THE LINKS AT CANYON SPRINGS

P.U.D. / M.D.P. PLAN / PEDESTRIAN PLAN

Re: The Links at Canyon Springs

MDP # 427-G

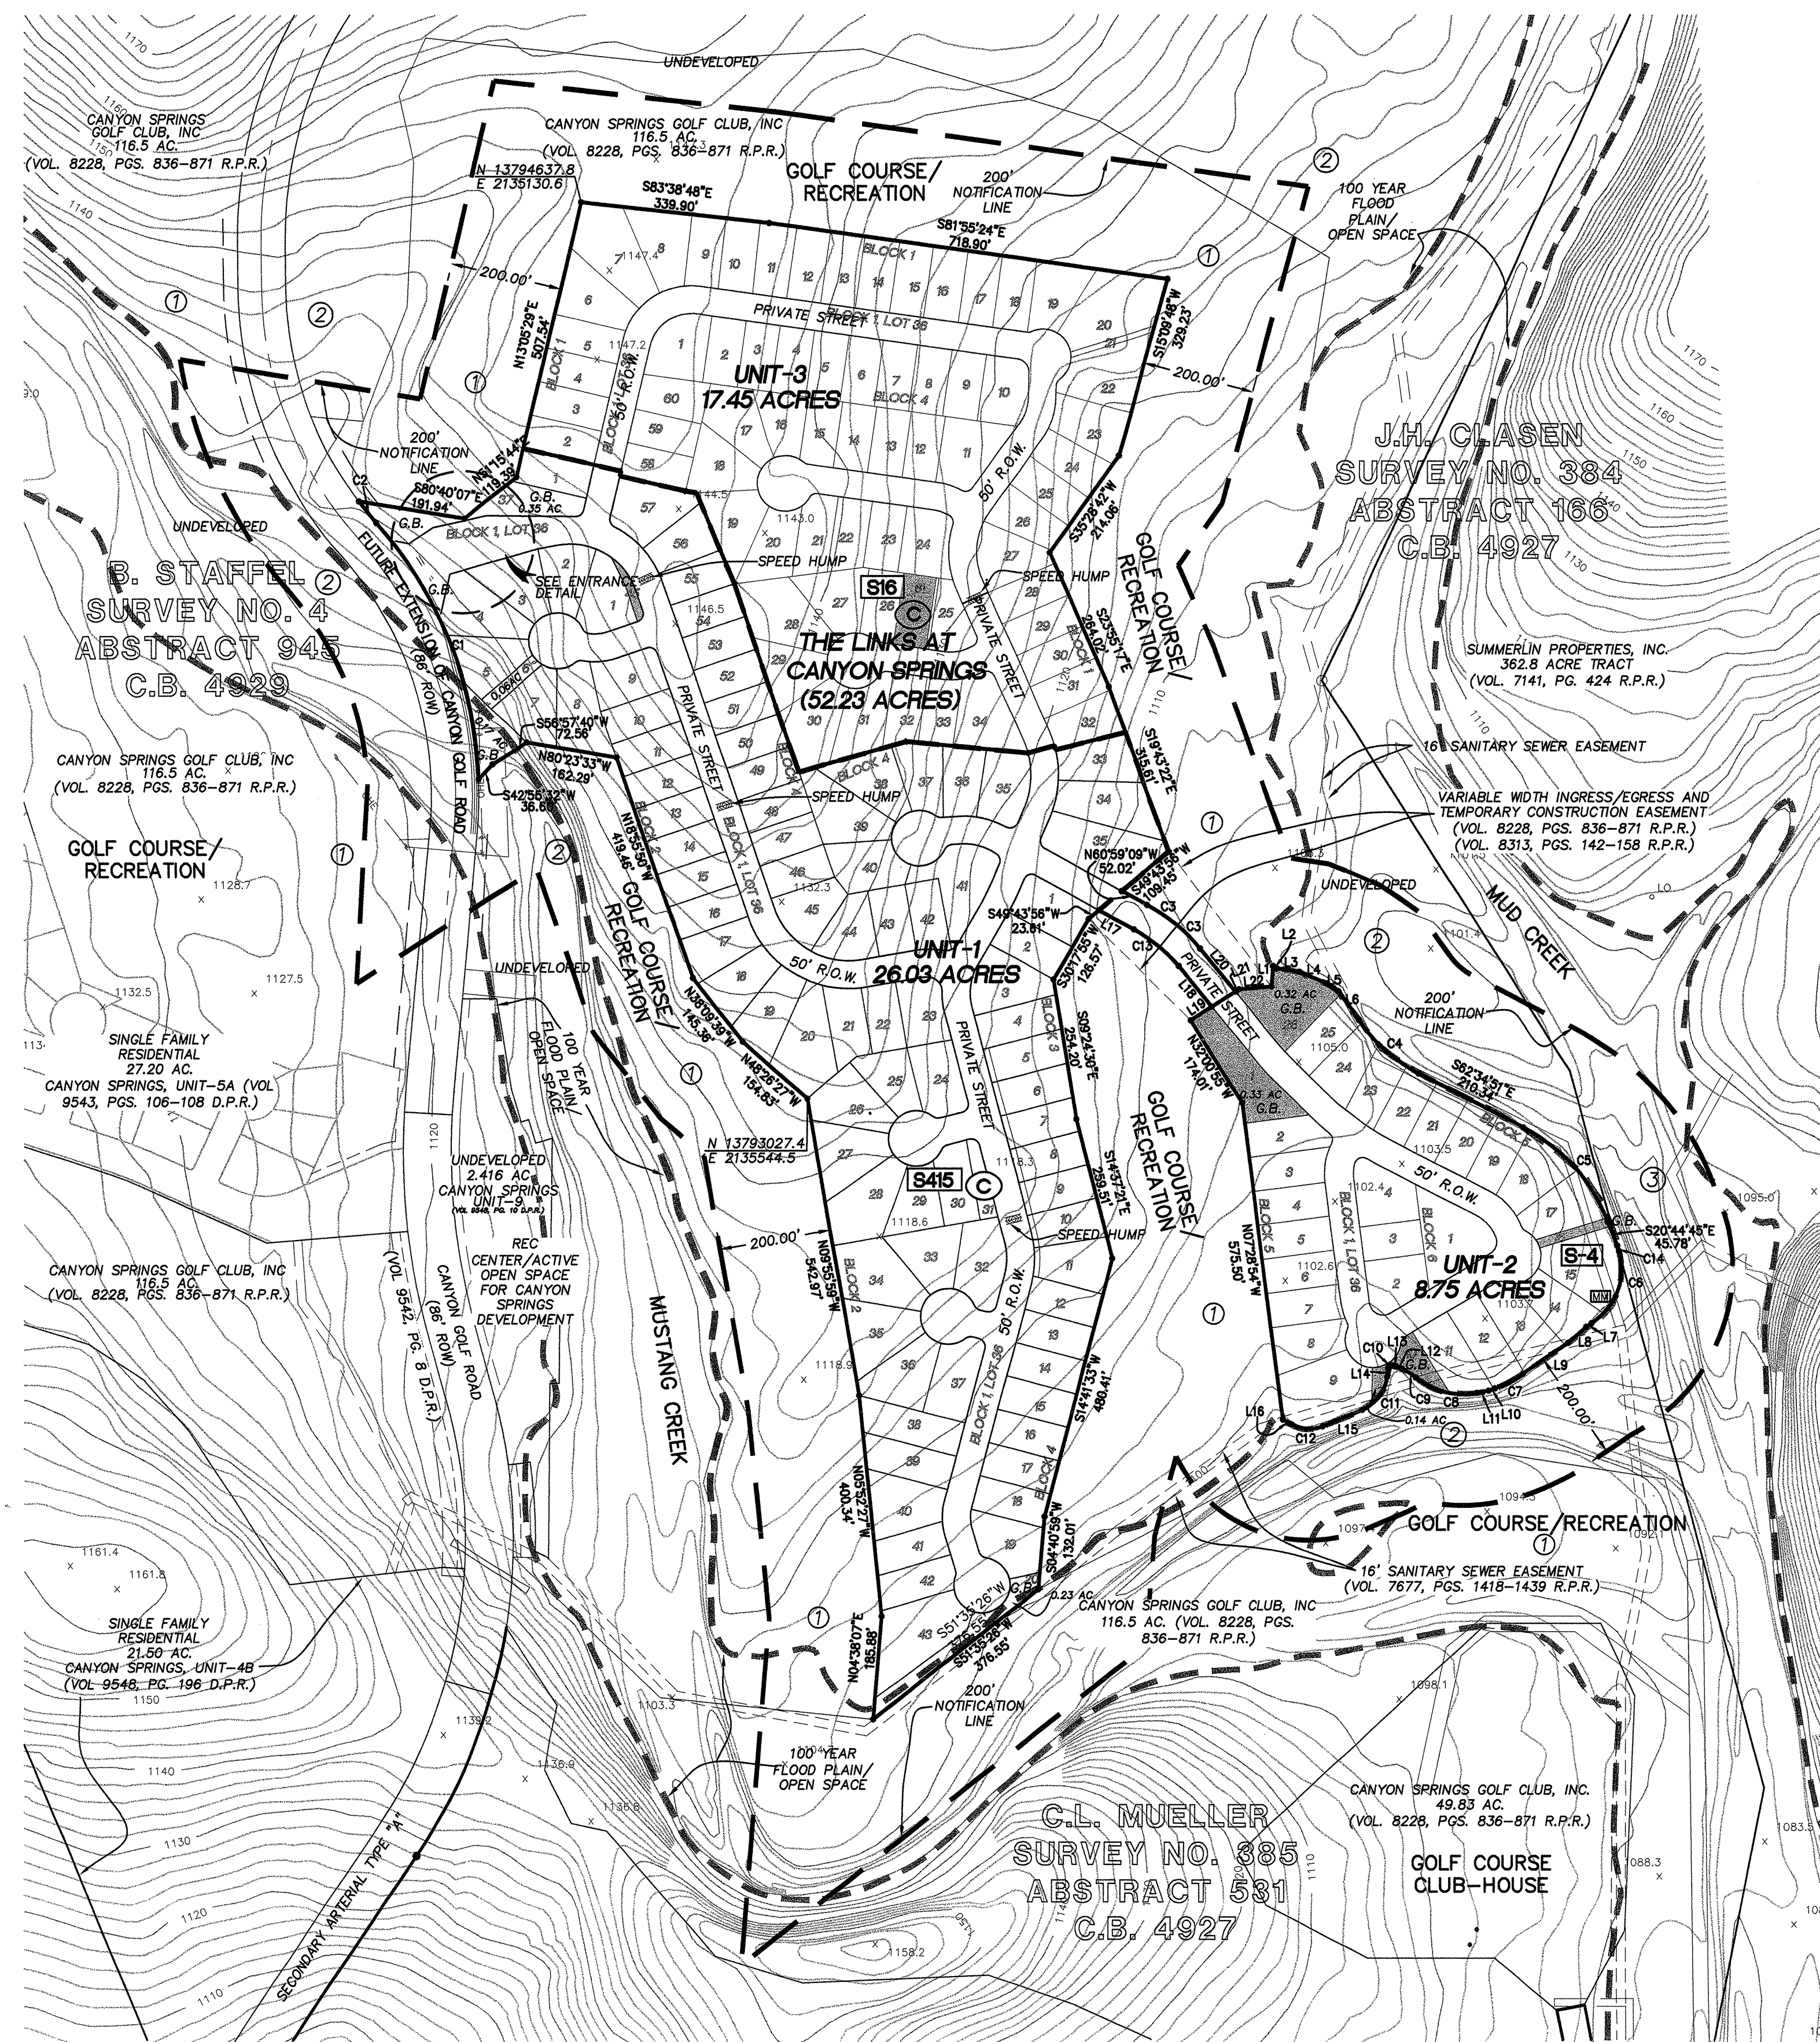
- The Development services Engineering Division has cited the following conditions as part of their conditional approval:
 1. A right-turn deceleration lane will be provided for the entrance by the developer on westbound Canyon Golf Road.

Storm Water Engineering has reviewed The Links at Canyon Springs PUD/MDP and recommends this project for approval if the following comment is placed on the PUD/MDP:

All finished floor elevations will be one foot above than the 100-year ultimate development floodplain.

1. This project is located above NRCS Dam No. 8 and detention will be required.
2. Please indicate what 100-year floodplain is drawn on the PUD/MDP plan (100 year existing or ultimate) and the source (FIRM map or the name of the floodplain study).
3. All other previous comments have been addressed or met.

Comments: HARDY OAKS IS ON THE MTP REQUIRING A MIN. OF 6' ROW. PROPOSE MOP ADDRESSES THOROUGHFARE.

Coordinate tree preservation
lay out development to maximize tree
preservation

NO SIDEWALKS SHOWN

THE LINKS AT CANYON SPRINGS (UNITS 1, 2 & 3) P.U.D. / M.D.P. PLAN / PEDESTRIAN PLAN

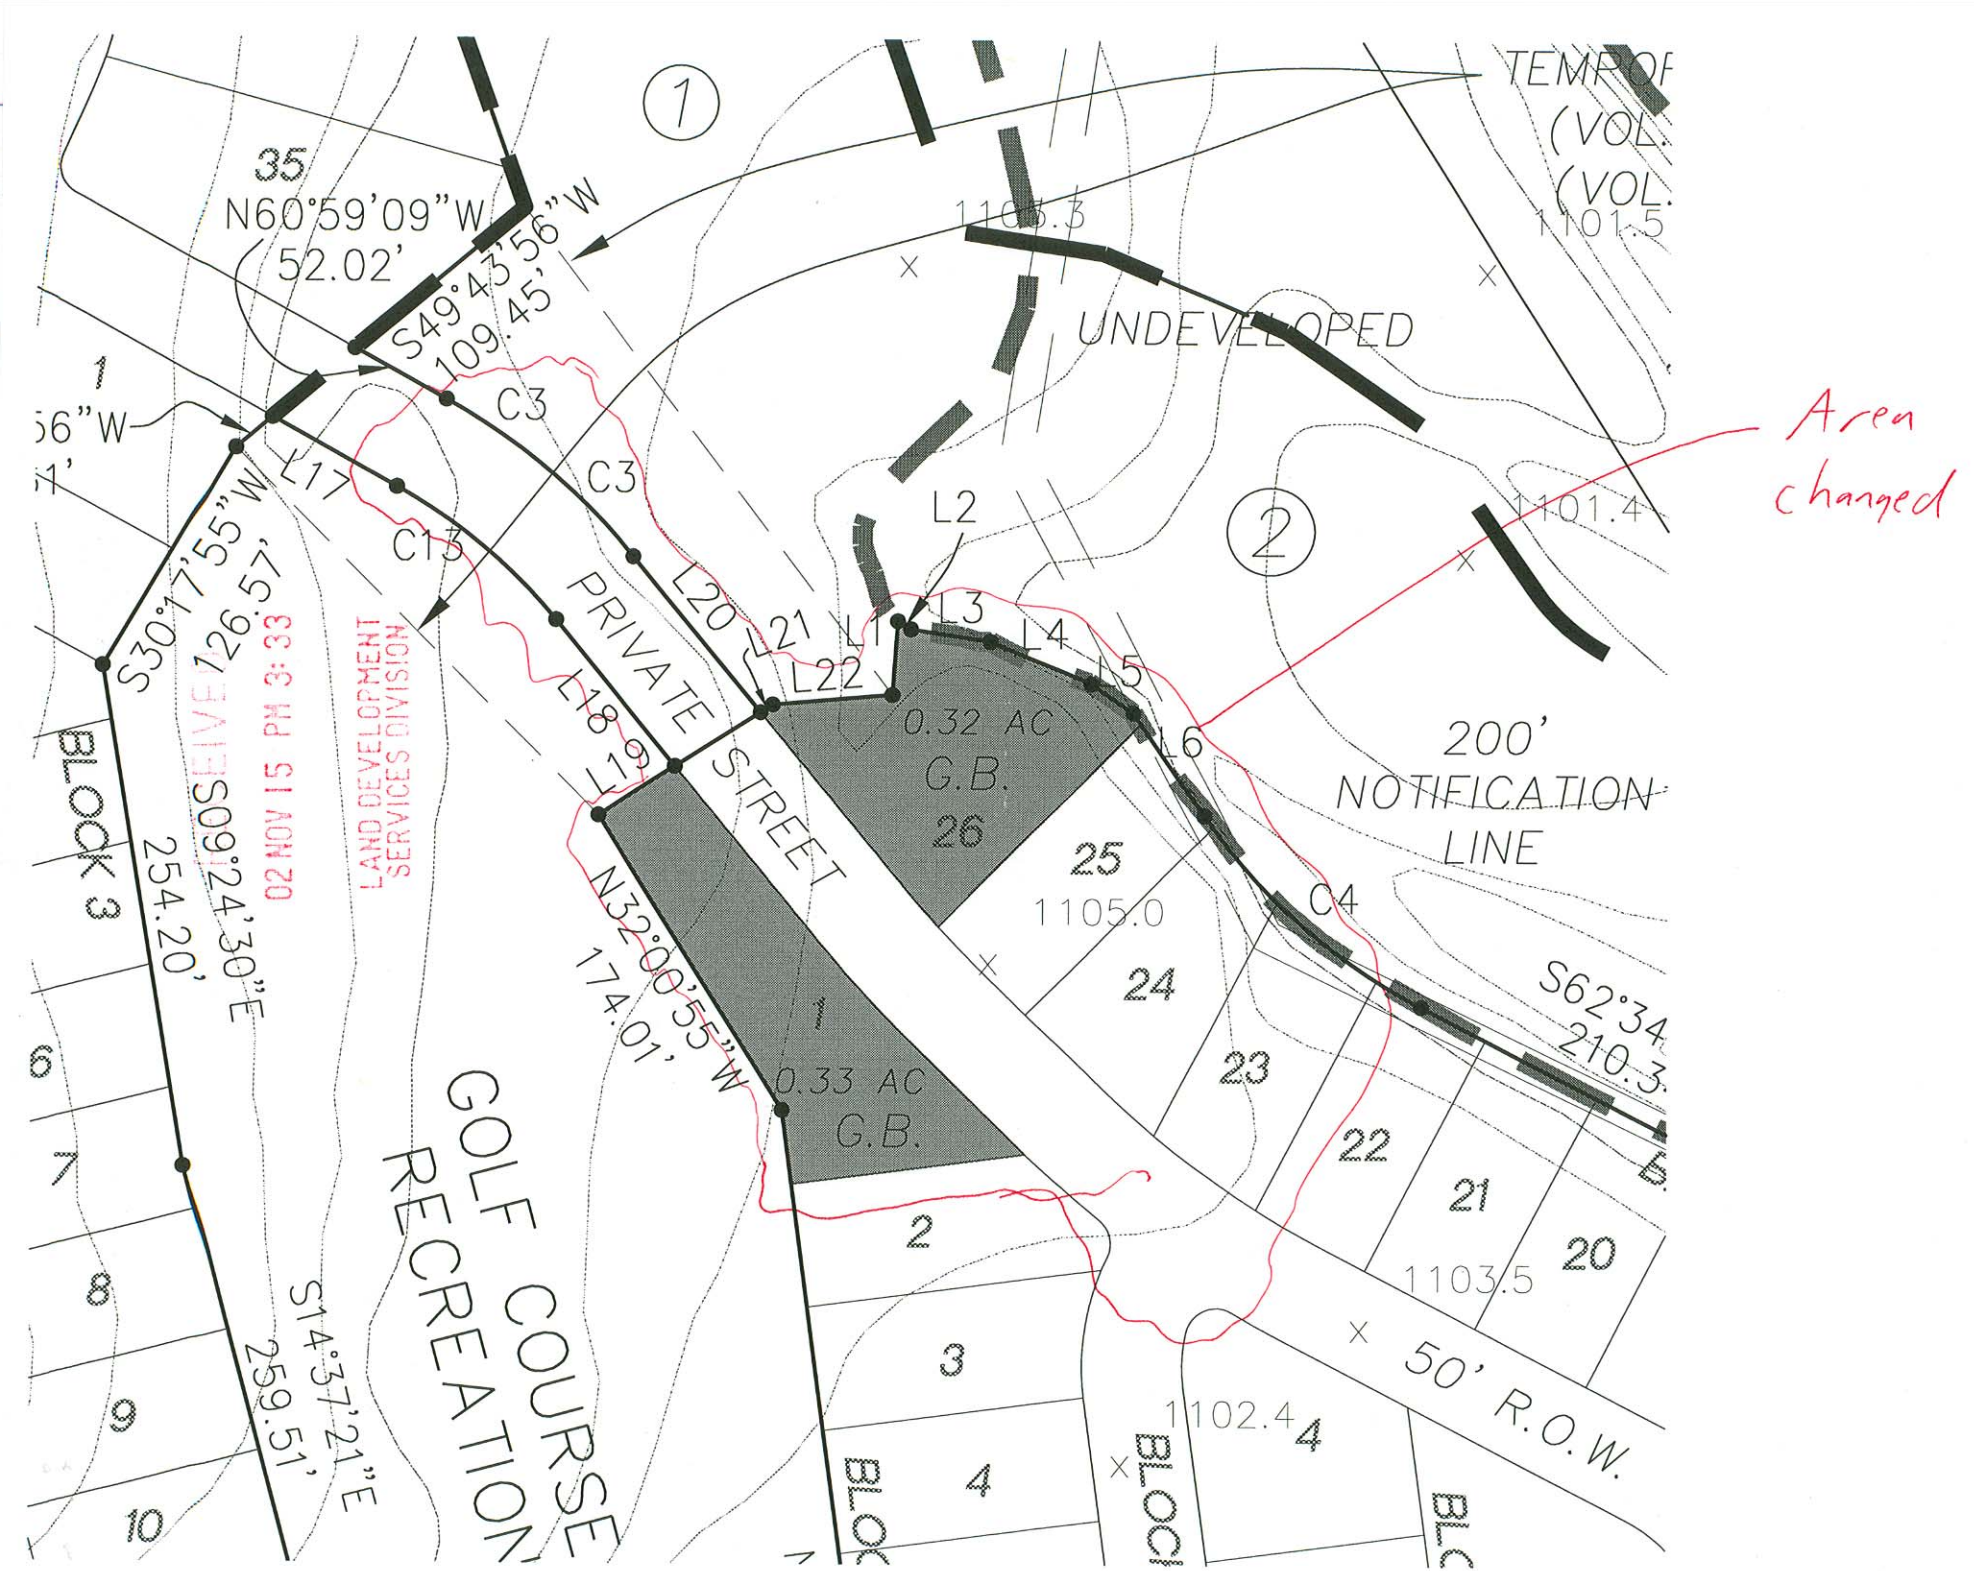
As we discussed, a slight change in the layout was made on Unit-2 of this plan. The road was moved to avoid conflict with a golf green. Because of this layout change two lots were moved across to the other side of the road.

This change results in no change in the Unit-1 layout, no change in the number of lots, and no change in density. We do not anticipate any problems with this because of these changes.
